Gullen Range Wind Farm

Modification Application (MP 07_0118 MOD 1)

Submissions Report

June 2014

Figure 4-1 - Vegetation types (Biodiversity Assessment July 2008)

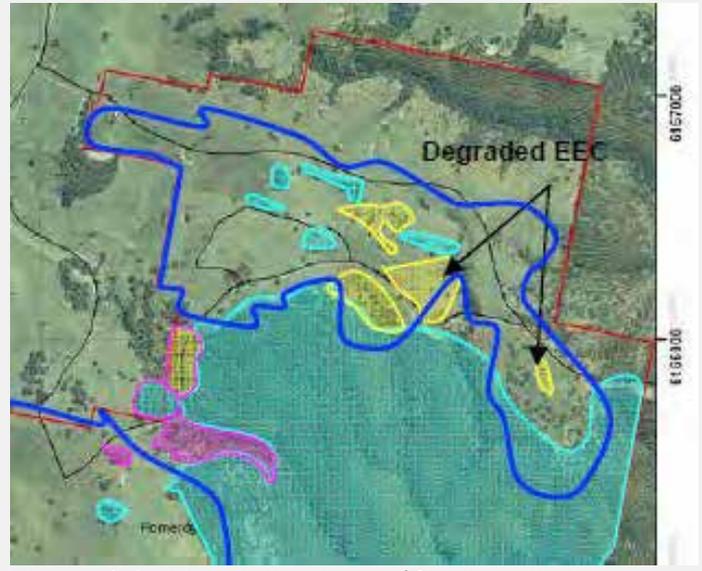
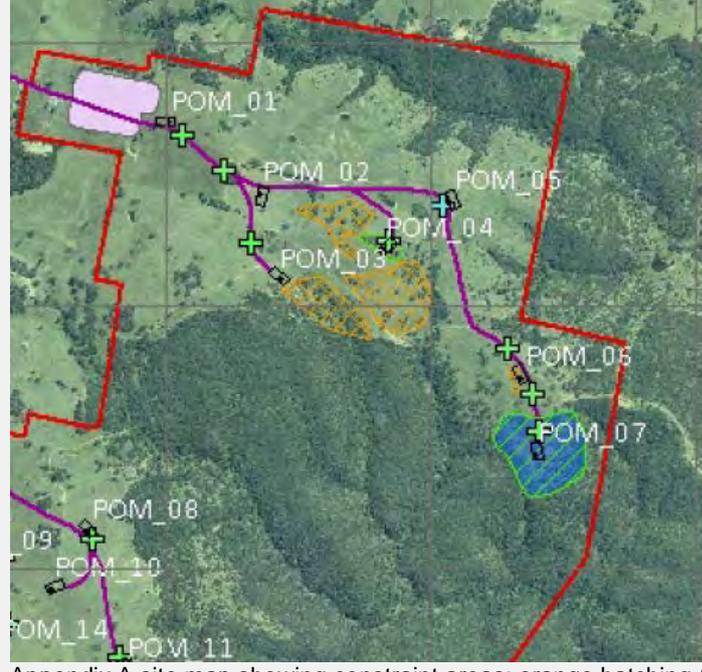
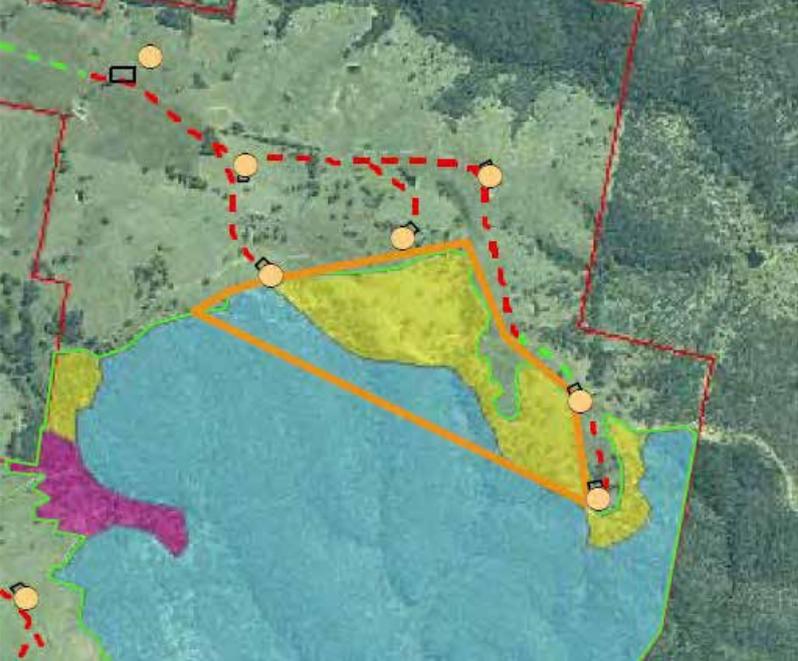
OEH Issue/Comment	Proponent's Response with reference to specialist advice
Comprehensive map or series of map showing correct boundaries and locations of all EEC, threatened fauna, threatened fauna habitat and buffers, the PVP offset area in relation to the changes	NGH has compiled biodiversity maps with the relevant information. See Figure 4-1 to Figure 4-3. OEH has requested further details be added to the mapping and GRWFPL will arrange updates and supply these to OEH. An onsite meeting will also be arranged with OEH to confirm suitability of the mapping and CHP.
Discrepancy between vegetation descriptions in EA March 2014 report vs CHP and EA (and BBMP and POMP) – see Attachment 1	There are differences in the mapping. These largely explain the differences in the vegetation descriptions. Refer to detailed responses for Attachment 1 below.
Is infrastructure proposed in the offset area?	Yes. Refer to detailed responses for Attachment 1 below.

avoided and included a 20m buffer and actions to manage indirect impacts. The layer is consistent in the BA, EA 2008, Flora and Fauna Management Plan (FFMP) and EA, March 2014. The latter two are slightly coarser due to re-digitalisation of the layer but the layers are essentially the same. The aim of this mapping is to manage impacts on areas of higher value.

Final layout as it relates to infrastructure required, as per consent condition	Refer Figure 4-1 to Figure 4-3.

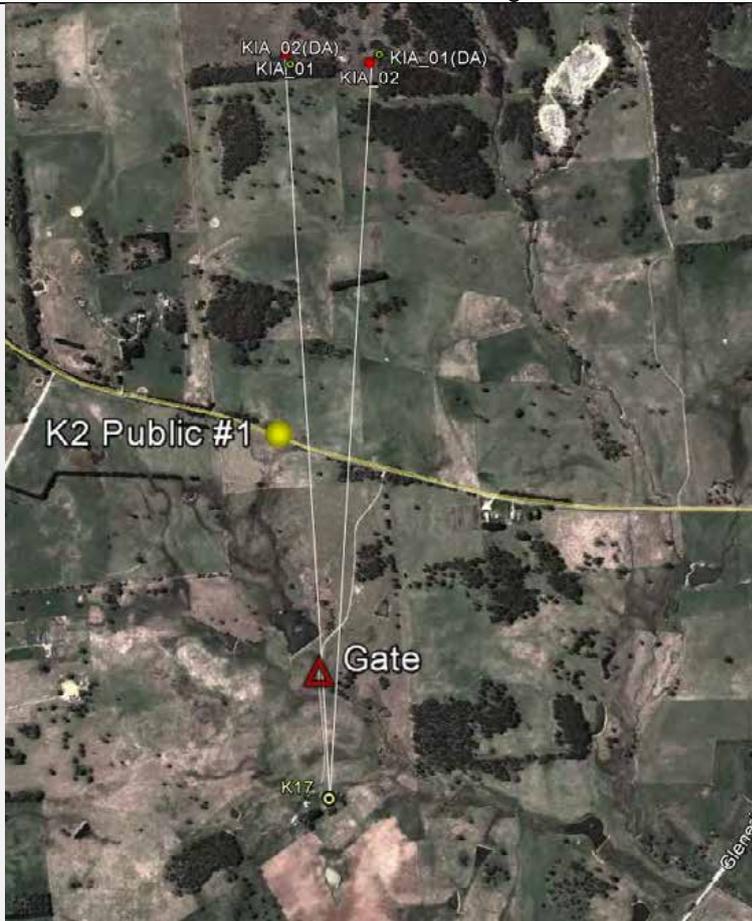
Submitter's Issue/Comment

Review of mapping and the content of the photo shows an angle of view of about 12 degrees which indicates a telephoto lens has been used to take the photo from 2.5km from the turbines. That will increase the size of the turbines in the image relative to the normal appearance.

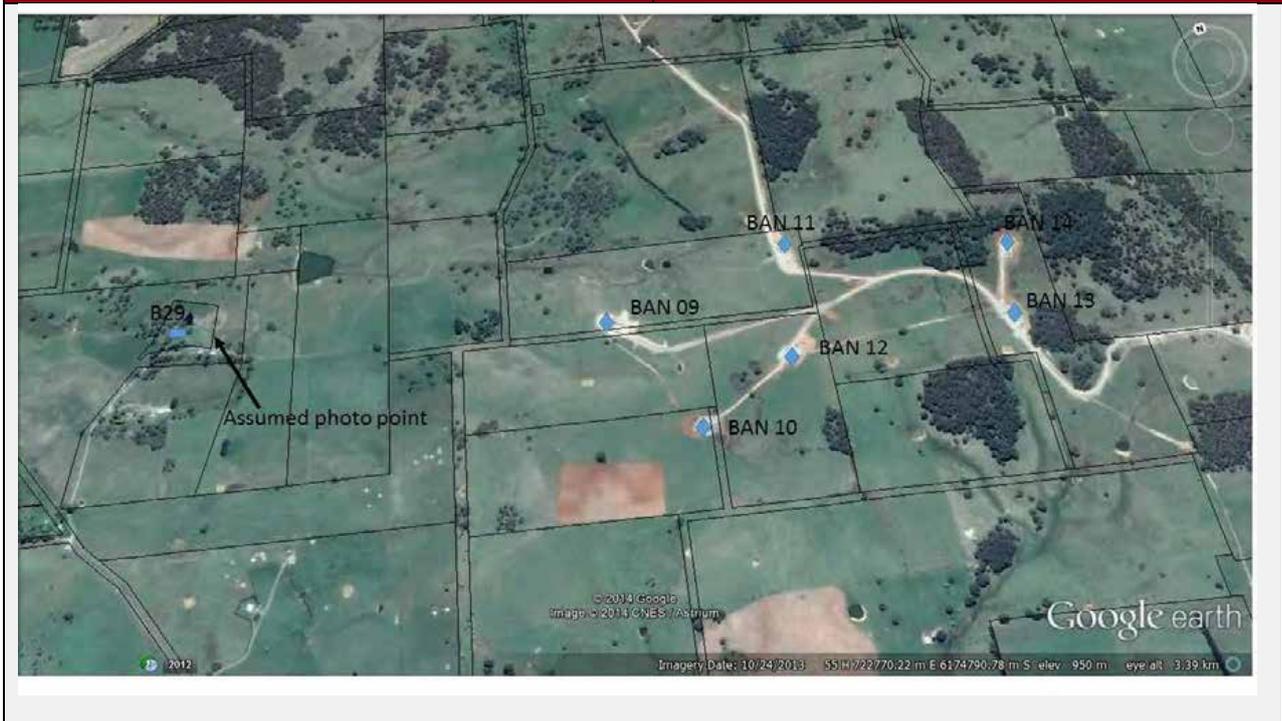
<p>Lost the view to the northeast.</p>	<p>The photo supplied by the submitter is to the east of the residence. The turbines to the northeast of B29 are set back further from the residence with minimum distance of 1,377m. The views have not been lost, they still contain many of the same elements.</p>
<p>Noise Impact</p>	
<p>On 4 April, BAN 3, 4, 6, 7 & 11, four turbines operating and were audible</p>	<p>It is expected that turbines will at times be audible at the residence location however, predicted noise levels shown below indicate that wind farm noise levels are well below criteria.</p>
<p>On 25 April, BAN 1, 2, 3, 4, 5, 6, 7, 8 & 11 were operating. Clear increase in noise outside the residence</p>	<p>The noise assessment by Marshall Day indicates that the predicted noise is well below criteria. Predicted noise data for Residence B29 is shown below.</p>
<p>Request removal of BAN 2 & 3 to mitigate noise or reengineering of this cluster and checks on compliance and ongoing monitoring of noise.</p>	<p>It is not clear why these two turbines have been proposed for removal by the submitter. A noise compliance monitoring program has been approved for GRWF.</p>

Analysis by ERM of the viewfield for B29. (Viewfield angle about 25 degrees)

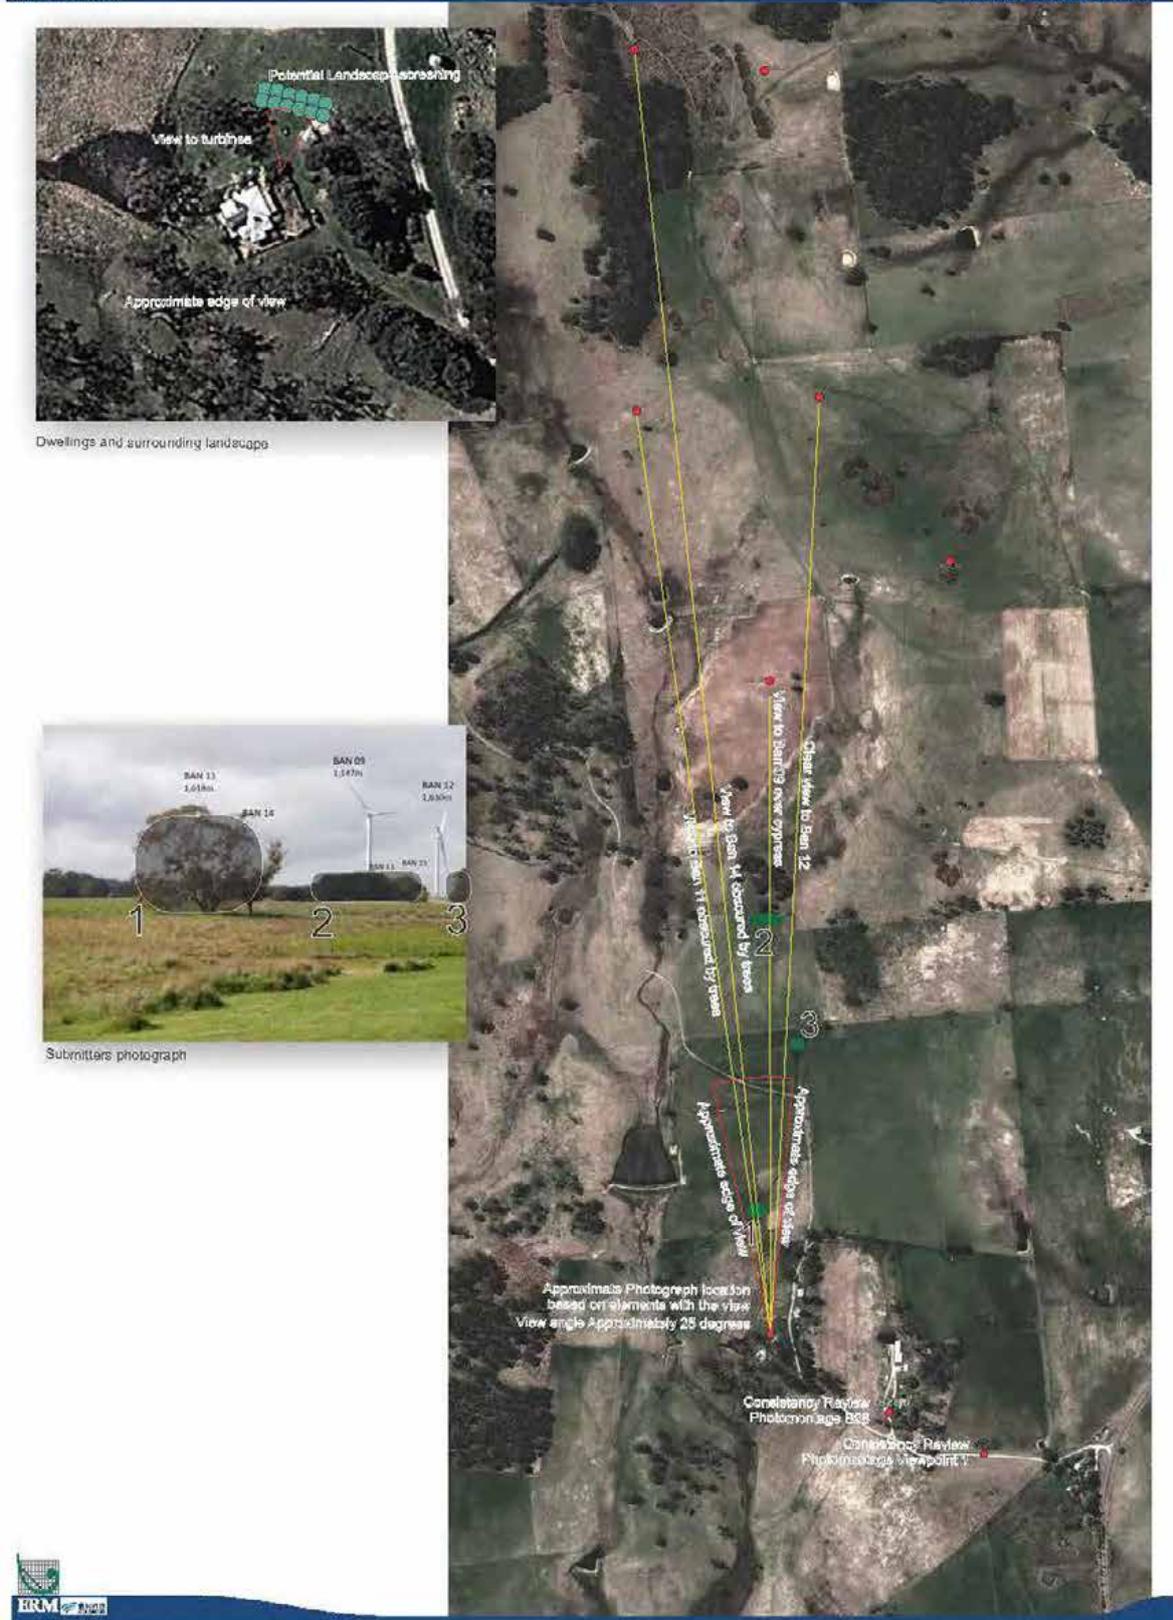
<p>Request removal of BAN 08 due to noise impact</p>	<p>Unclear why the submitter suggests removal of this turbine in relation to noise impact</p>
<p>BAN 11 is at a distance of 1618 metres. The noise it generates during particular wind directions is unacceptable, disturbing and disruptive to our lifestyle.</p>	<p>The submitter has made observations that warrant investigation. GRWFPL would be interested in discussing the submitter's experiences and investigating the indicated impacts further in the context of the wind farm noise compliance. Were the noise impacts assessed as non-compliant then GRWFPL is obligated to addressing the impacts.</p>
<p>BAN09 at 1146m is expected to have a greater impact and its removal is sought.</p>	<p>BAN 09 is the closest turbine. In respect of noise, its impact has been assessed together with the other turbines and there is a reasonable buffer between predicted noise levels and criteria to</p>

Submitter's Issue/Comment		Proponent's Response									
		ensure compliance when all turbines are operating.									
Noise from the limited number of operational turbines that are currently operational is proving to be an irritant and disturbance causing stress		As indicated above, GRWFPL would like to meet with the submitter to discuss their experiences and the matters that are of concern to assess whether there is a need for variation to the operation of the wind farm.									
Turbine noise can be heard at the same time as the wind rustling through trees can be heard.		This indicates that turbine noise is similar to background noise levels. Significant differences in noise levels of either the trees or the turbines would be likely to lead to dominance of that form of noise.									
We don't know the full impact of the noise from the turbines as not all operating but we expect the impact to be greater		The wind farm noise levels will be greater with the full wind farm operating and that is why compliance testing is only done once the full impact is occurring. The predicted noise levels and margin below criteria are shown below

Figure 5 1 Residence B31a location and turbines within 5km

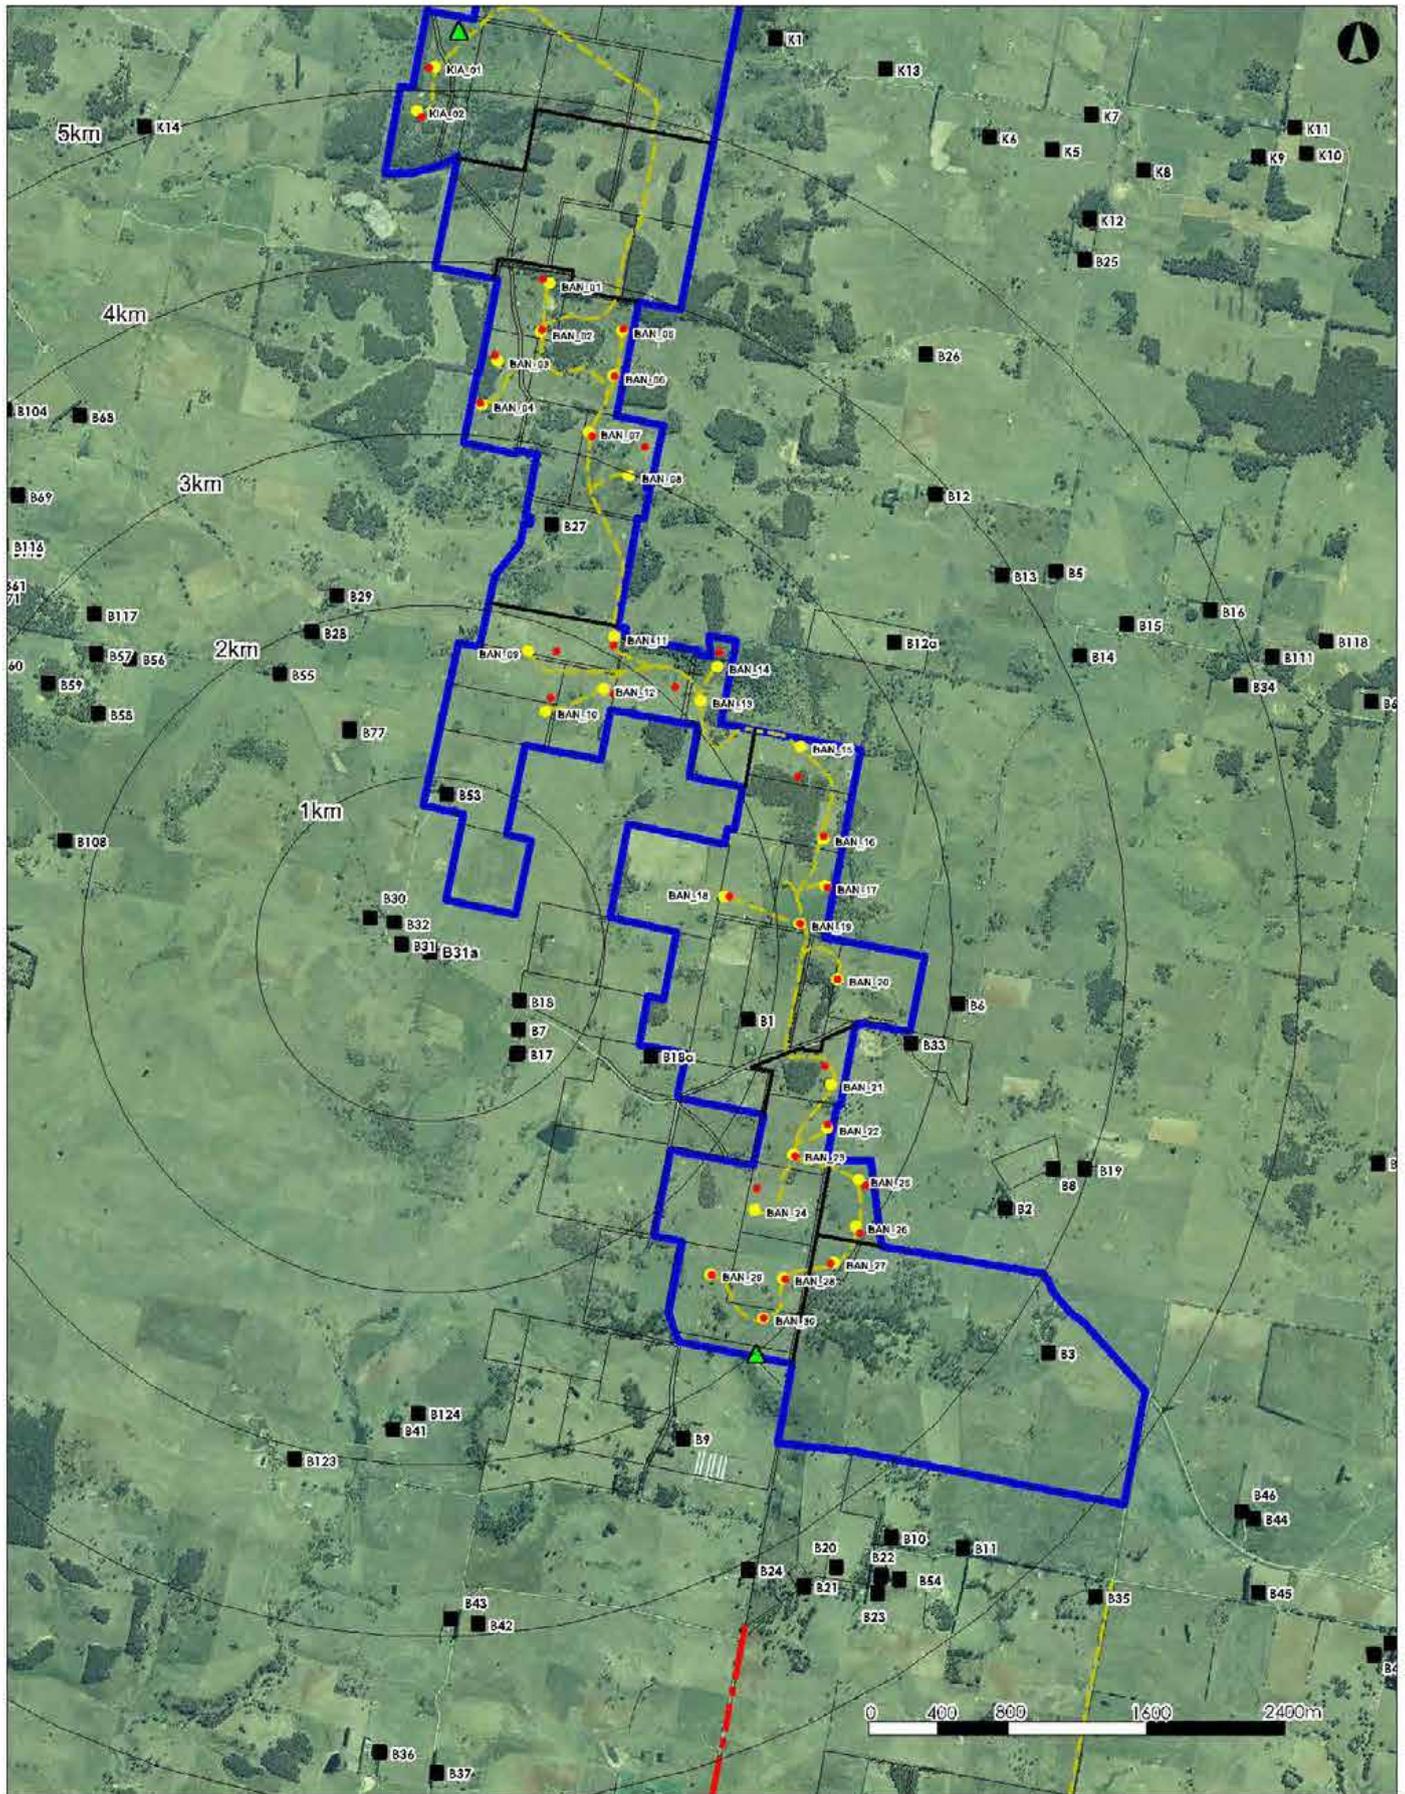
The submitter has two 25 acre blocks of land with frontage to Range Road that runs between Grabben Gullen and the wind farm. A residence is located on the eastern block at about 1.53km from the closest turbine, BAN_10. Four turbines are within 2km of the residence. The residence was not included in previous assessments and accordingly this SR provides the data sheet similar to those provided in the EA, March 2014 for other non-associated residences within 2km of the wind farm as well as Figure 5.1 showing the turbines within 5km of the residence.

Shadow flicker for the residence location B31a, has been assessed as 3 hours / year.

Visual impact for the modifications is indicated by reference to the photomontage for Viewpoint B31 (Appendix 9), at 172 metres to the west of B31a residence location. A photomontage for Viewpoint 2 was included in the EA March, 2014 and is about 780 metres southeast of B31a.

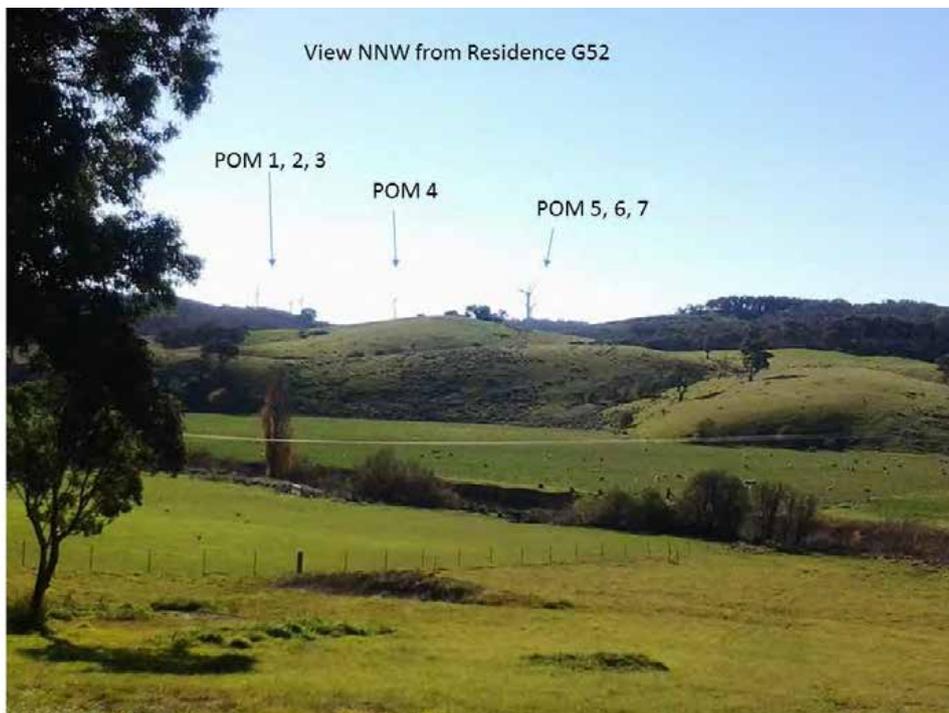
Submitter's Issue/Comment		Proponent's Response									
	Noise Criteria & Predicted Noise (dB) - Goldwind Turbines and Final Design Layout										
(m/s)	3	4	5	6	7	8	9	10	11	12	
Predicted Noise Final Design Layout	32.0	32.0	32.1	32.7	33.8	34.5	35.2	35.7	36.0	35.9	
Noise limit Criteria (Condition 2.15)	35.0	35.0	35.0	36.2	37.5	38.8	40.2	41.5	42.9	44.4	
Amount Below Criteria	3.0	3.0	2.9	3.5	3.7	4.3	5.0	5.8	6.9	8.5	
We have contacted Department of Planning numerous times in an attempt to gain some response, to no avail. It is hardly likely the oversight is coincidental, after so many attempts to contact.		GRWFPL received a call in late March 2014 from the Department but due to the departure of the employee receiving the call, no response occurred. A further call from the Department in April was responded to. GRWFPL phoned the landowner and arranged a meeting at the residence location on 6 May 2014. Further consultation is proposed. As the initial landscaping inspections are being undertaken, the residence was also scheduled for inspection. The inspection was undertaken on 16 May 2014. The turbines seen in the image below (obtained during the inspection) have been indicated by the landowners as the turbines that are of concern to them in respect of visual impact. While screening of the turbines could be arranged using vegetation, this may not be the landowner's preference.

The following photo was taken by the Landscape Architect that is providing advice on landscaping at residences. The landscape architect stated that "There were other turbines visible further to the West but Sue (Madden) indicated that the ones that I photographed were the only ones of concern." The landowners indicated they are not concerned by the turbines of the Gurrundah Group to the south. This is due to their northerly aspect and mature trees immediately to the south of the residence.

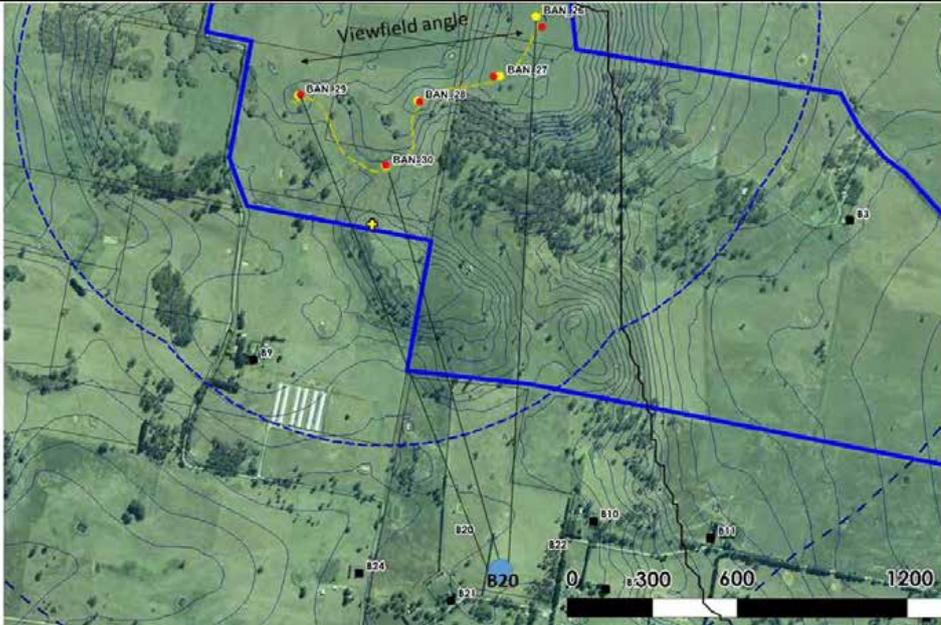
The photo shows the view to residence B20 and the turbines on the hill north of B20. The map below shows the locations of the residence B20 and the closest turbines.

This image shows the wind farm viewfield angle (about 30degrees) from the B20 residence and turbines within 2km. The turbines are generally at the approved locations. BAN 26 has moved further away from B20.
